**Site Details & Floor Plan**

**Recommendation:** Common Council approval of the Site, Landscaping, and Architectural Design Review for EZ Mart, a proposed neighborhood retail use, at 6843 W. Beloit Rd. (Tax Key No. 489-0071-000) subject to the following conditions:

Re: **EZ Mart Remodel**  
6841 W. Beloit Rd.  
West Allis, WI

### Landscaping and Parking Plan

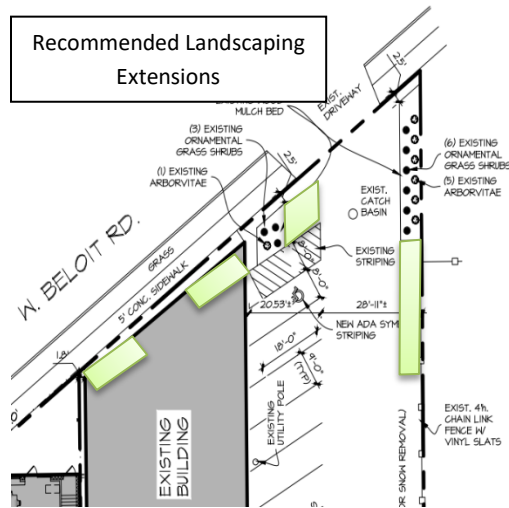
Landscaping features are indicated on the site plan submitted by the applicant. Two landscaping features consisting of arborvitae and ornamental grass shrubs exist on the site already. Considering the visual impact this site has along Beloit Rd. Planning staff recommend the extension of these landscaping features in the parking lot to reduce the visual impact of the lot in key regions. Extending the existing features would add screening to the lot, while maintaining some potted or hanging planter features underneath the entrance awning would create an attractive storefront feature for the business.

The parking lot is shared between the 6841 and 6843 W. Beloit properties, which are under the same ownership. There are 22 existing parking spaces indicated on the site plan with one new ADA stall indicated toward the driveway along Belot Rd. The parking lot appears to be in decent condition, with small regions in need of light patching and repair.

The parking lot is currently surrounded by 6 ft chain link fencing with vinyl slats to the east and to the south of the site. Although the southern portion of fencing appears to be in good condition, the fencing to the east adjacent to residential properties requires repair. Staff is recommending repair or replacement of the fencing. If replaced, a wood or composite fence is recommended instead of chain link fencing.

Although outdoor seating is proposed in the project description submitted by the applicant, the site plan doesn't show the potential layout. Staff recommends an updated site plan to indicate the location of any proposed outdoor seating areas prior to final occupancy approval. A large portion of the parking lot on site remains free of parking and could potentially facilitate a small outdoor seating area. A new, 4-sided wooden refuse enclosure will be constructed site toward the back

of the lot, compliant with refuse enclosure requirements for commercial uses. Lastly, staff note that several flood lighting features are indicated on the site plan and appear to remain in good condition. However, staff are concerned that these features project outward toward the residences to the east of the lot. To remedy this, staff recommend that existing lighting features be amended or replaced with new fixtures to direct light toward the ground rather than outward.

1. Common Council consideration of appropriate liquor licenses and extension of licensed premise associated with the proposed use.
2. A revised site, landscaping, and architectural plan being submitted to the City Planning Office to show the following: (a) additional landscaping areas and planting details along W. Beloit Rd. and within the east side of the parking lot area, (b) Indicate the nature of and location of proposed outdoor seating features on the site plan; (c) note on plan to reference pavement repair areas; (d) repair or replace the eastern fence adjacent to residential properties. If a replacement is necessary, a new 6-ft tall wood fence or composite fence (non-chain link) fence being indicated on plan; (e) note on plans to indicate repair to canopy sections disrepair due to nesting activity. Remove bird nesting in the canopy entrance of the building (f) exterior color painting details and repainting of existing exterior painted surfaces.

3. An exterior site lighting plan for the overall properties being provided to identify existing and proposed exterior lighting. Fixture details being provided. Replacement of flood lighting with full cut off fixtures (down-lighting) to avoid light splay beyond property limits.

**PROPOSED NORTH (BELOIT)  
ELEVATION**

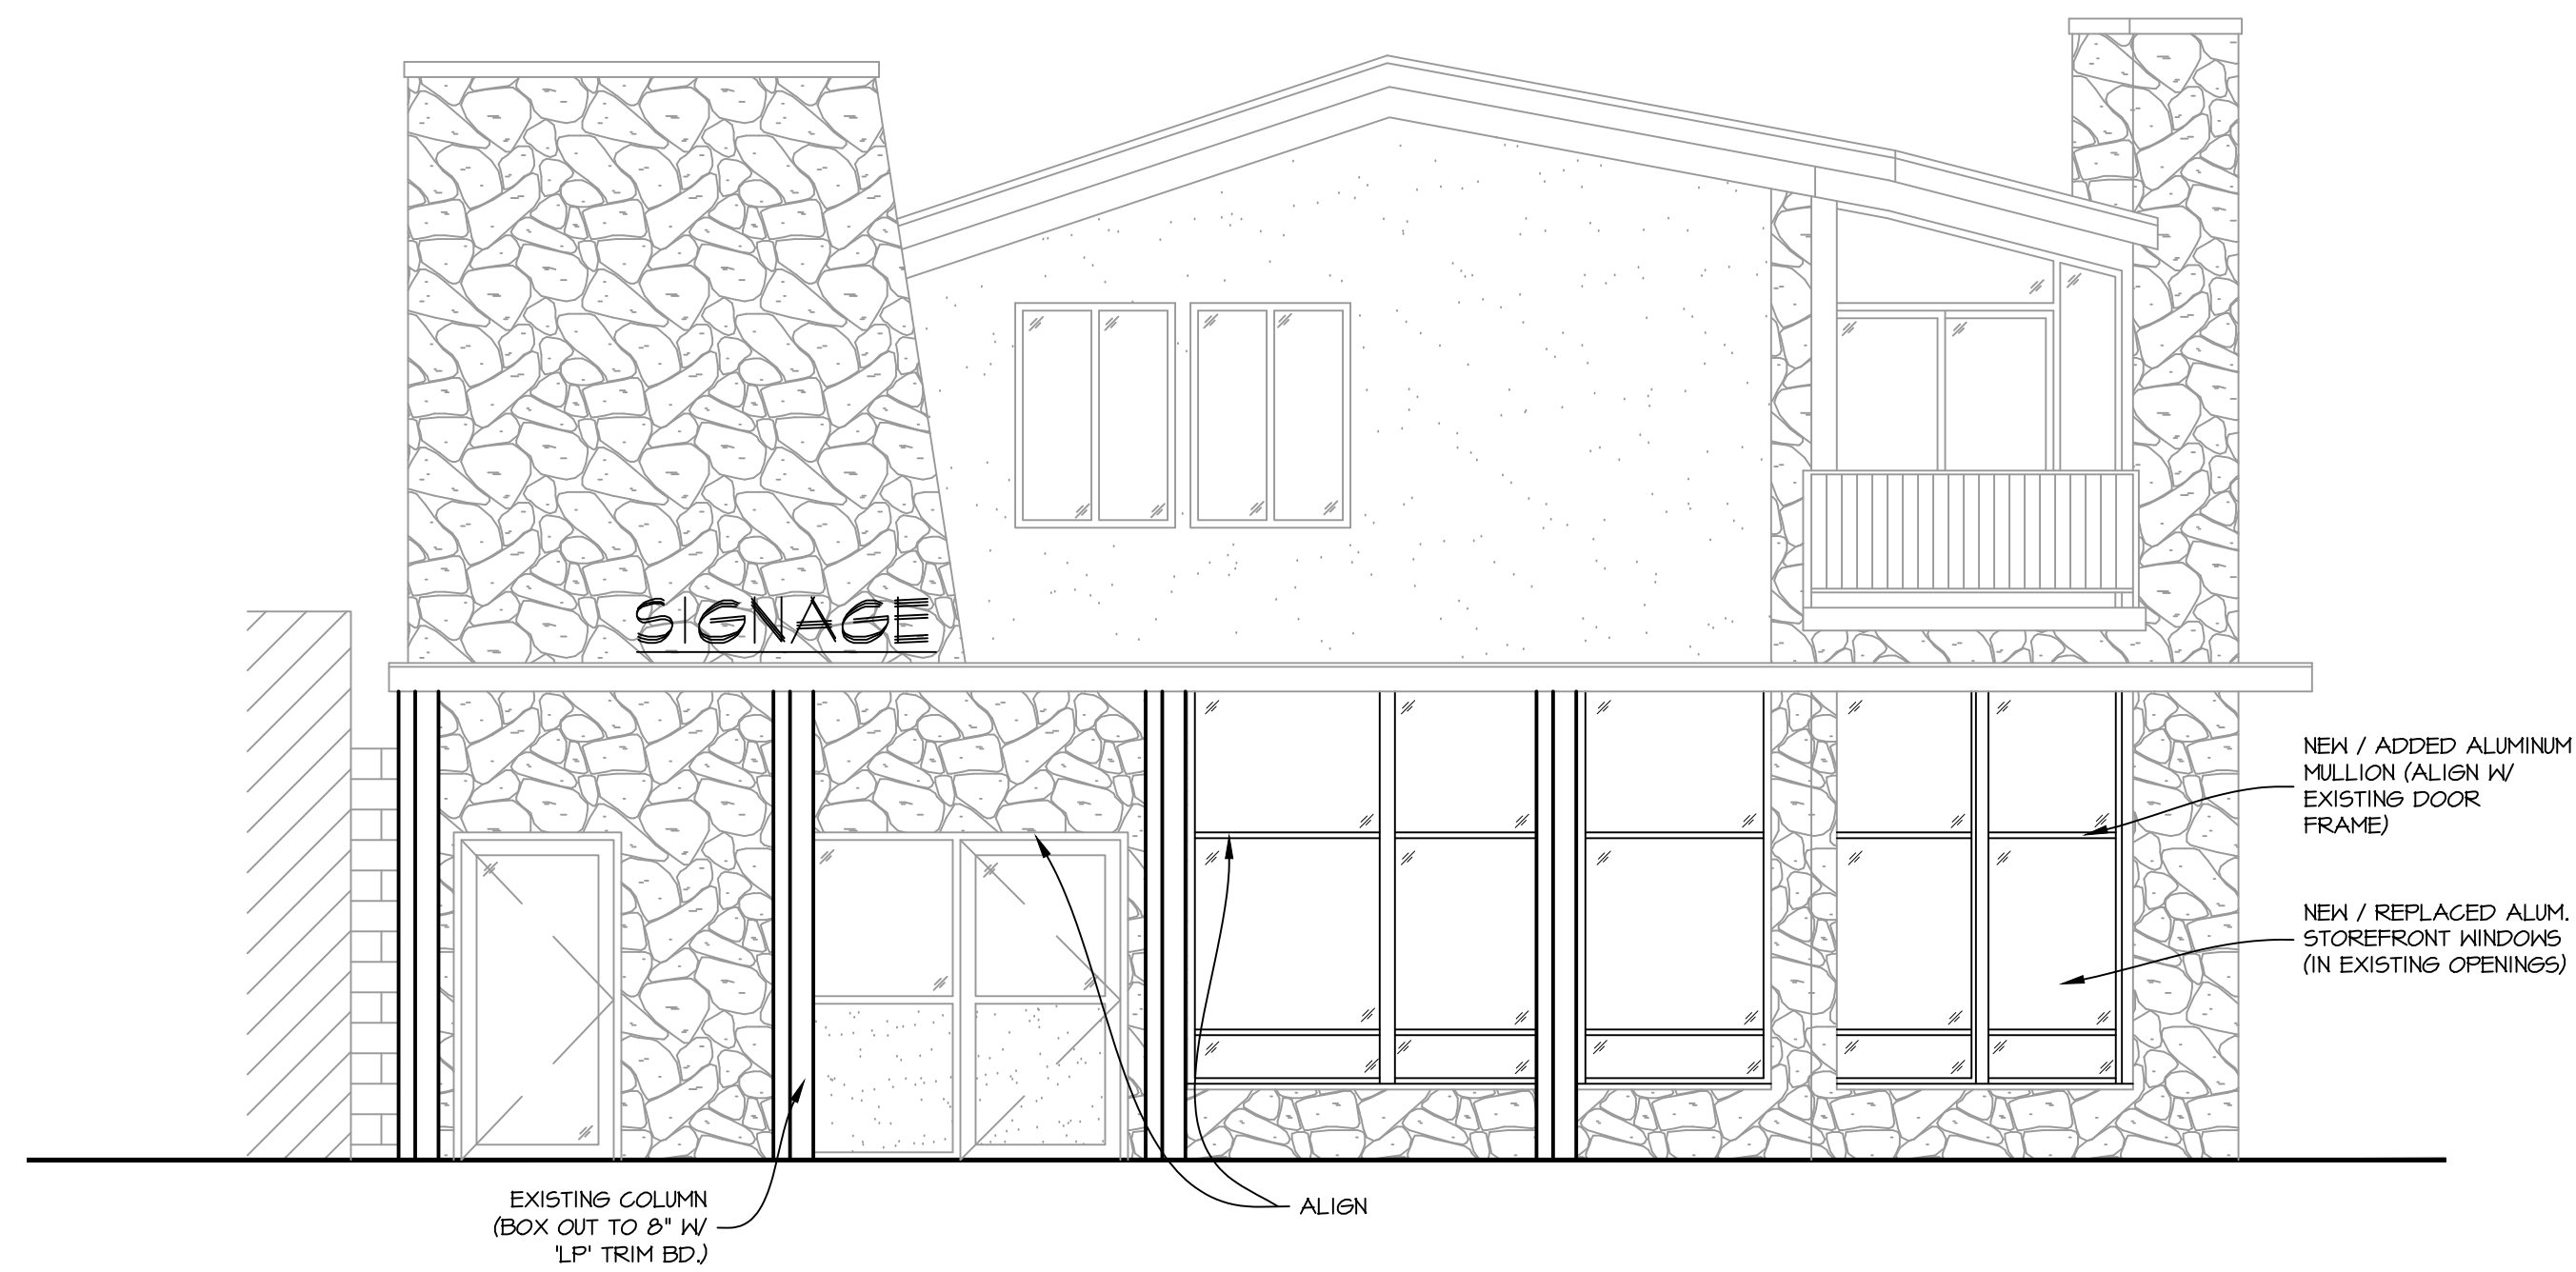
Few changes are proposed to the building's exterior and façade. The applicant indicates the replacement of existing windows along the storefront with new energy efficient windows in the same locations. Additionally, the proposed architectural changes facing Beloit Rd. show that the existing columns

will be boxed out with 8" LP trim with new paint to update the façade. The old ASC

Milwaukee signage will be replaced with signage for the proposed business, subject to permitting approval. Upon visiting the site, staff noticed that a large number of birds are nesting underneath the canopy entrance to the building, causing damage to the canopy. This issue will need to be remedied by the applicant, with minor repairs required to sections of the canopy in disrepair.
